SI B65 16 16  
Audio, Navigation, Monitors, Alarms, SRS

## Recall Campaign 16V-071: Driver's Front Air Bag Module E82 E88 E90 E91 E92 E93

This Service Information bulletin Replaces SI B65 04 16 **dated June 2016** for E82 E88 E90 E91 E92 E93 vehicles

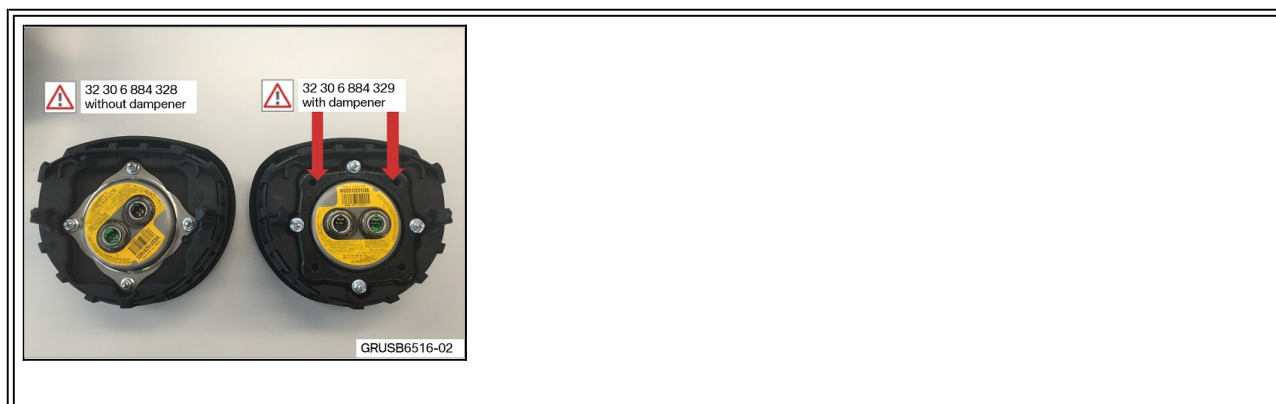
Part Number	Description	Quantity
32 30 6 884 328	airbag module driver's side base <b>without</b> vibration absorber (for all E82, E88, E91 and E92) or (for all E90 and E93 with the exception of the engines listed for part number 32 30 6 884 329 below)	1
	OR	
32 30 6 884 329	airbag module driver's side with a vibration absorber (on E90 only with engine S65 or M57Y) and ( on E93 only with engine S65 or N54T or N55)	1

**Note:** Original part coming out of the vehicle may not match the replacement part.

This applies to vehicles originally equipped with or without a dampener.

**It is important that the correct airbag module is installed. Only install the air bag**

**module based on the model and engine variant listed in the parts information. Do not mix up the two parts. Refer to the photos above. Printing this SI in color will make it easier to see the difference in the parts.**
